Interim Staff Position on Environmental Qualification of Safety-Related Electrical Equipment

Including Staff Responses to Public Comments

Resolution of Generic Technical Activity A-24

Manuscript Completed: November 1980
Date Published: July 1981

Figure C-1. Qualification Profiles for BWR and Ice Condenser Containments

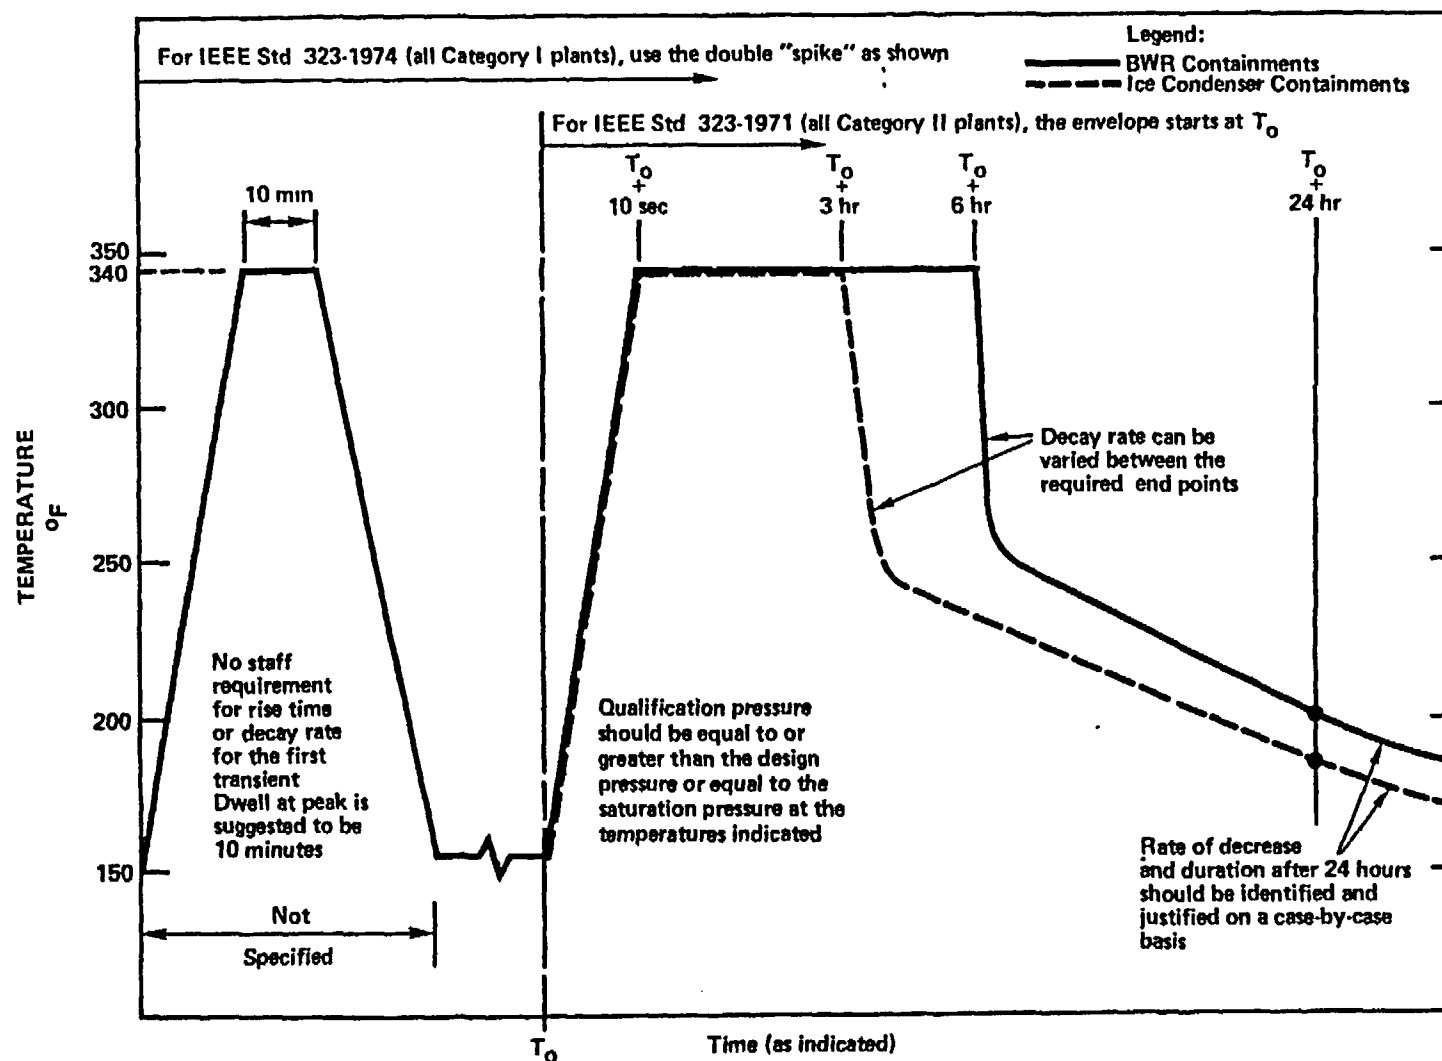
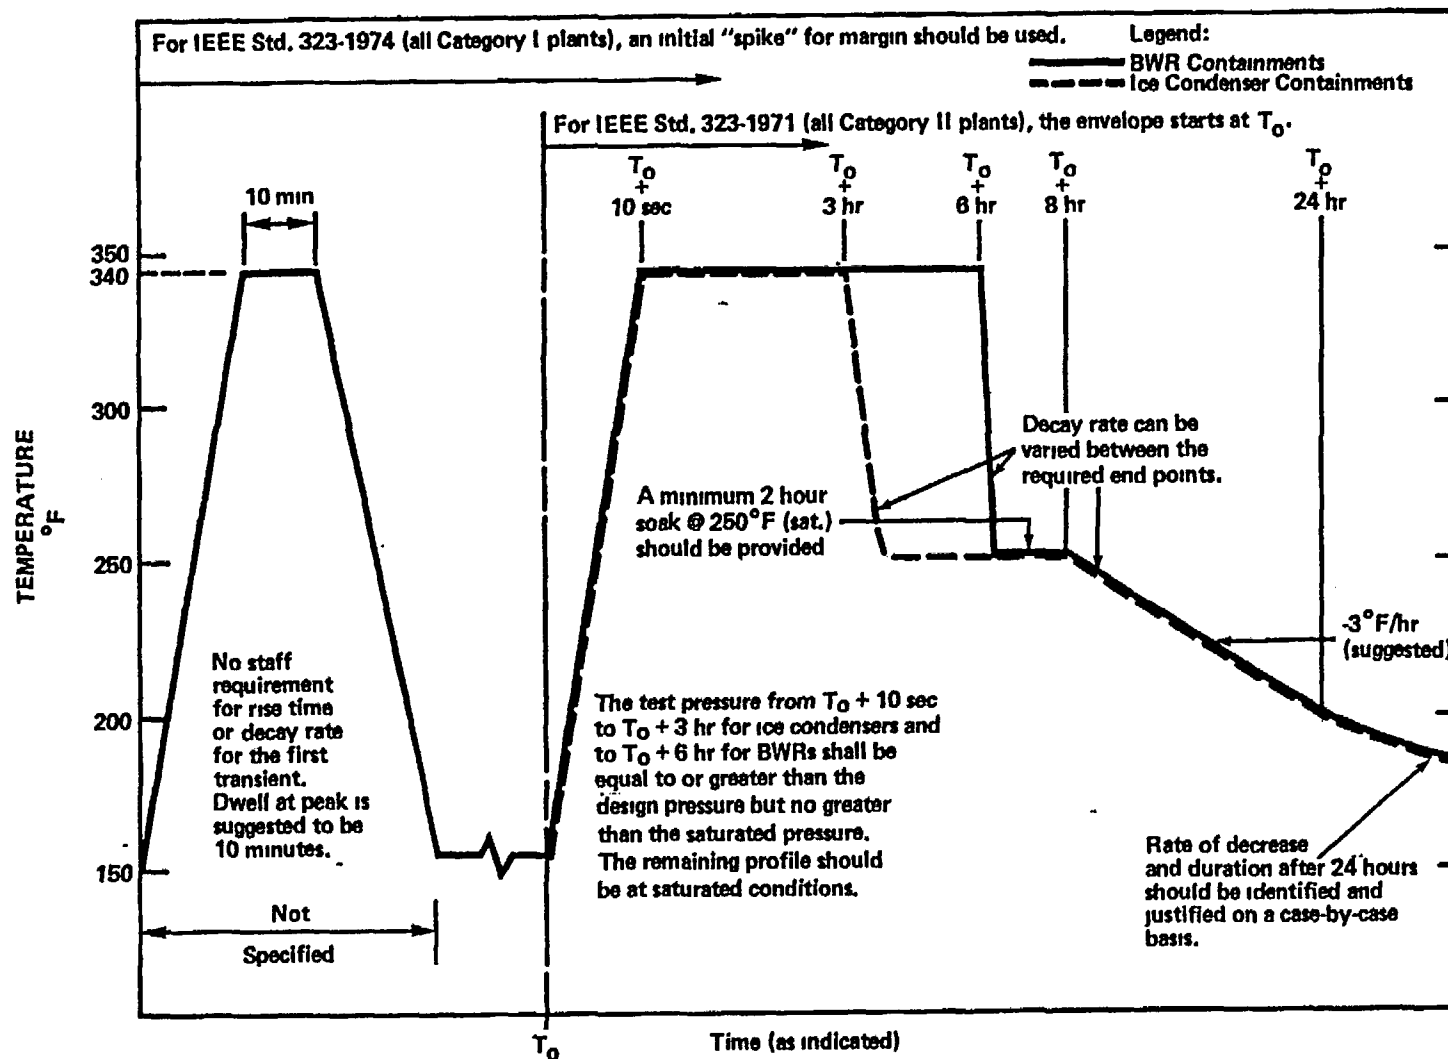
COMMENT NO. 97A: We feel and have felt that there is inherent danger
(Appendix C) in publishing a "universal" environmental profile for use by all in qualifying equipment (Figure C-1). This is the reason IEEE 323-1974 listed numeric values as "typical" and to be used with caution. We recommend the same here.

COMMENT NO. 97B: Delete note on use of "double spike" (Figure C-1) based
on our general comments on Section 3. Also, we feel and have felt that there is inherent danger in publishing a "universal" environmental profile for use by all in qualifying equipment. This is the reason IEEE 323-1974 listed numeric values as "typical" and to be used with caution. We recommend the same here.

One should recognize that the curve in Figure C-1 is provided for those BWR and PWR ice condenser facilities which do not have plant-specific accident profiles available for use in their specific equipment-qualification program. It would be possible for a utility/applicant to provide, on a case-by-case basis, documentation which yields a plant-unique curve. Should a plant owner want to upgrade a currently installed spray system, it may be possible to shorten the time for the superheat qualification test by providing adequate justification that the spray system will indeed actuate and serve to mitigate the accident, thereby yielding a substantially lower environmental profile. Because Sections 1.1(3) and 1.2(3) clearly allow the use of the plant-specific profiles, no modification was proposed as a result of these comments. (See also staff response to Comment No. 57 regarding the use of a "double spike.")
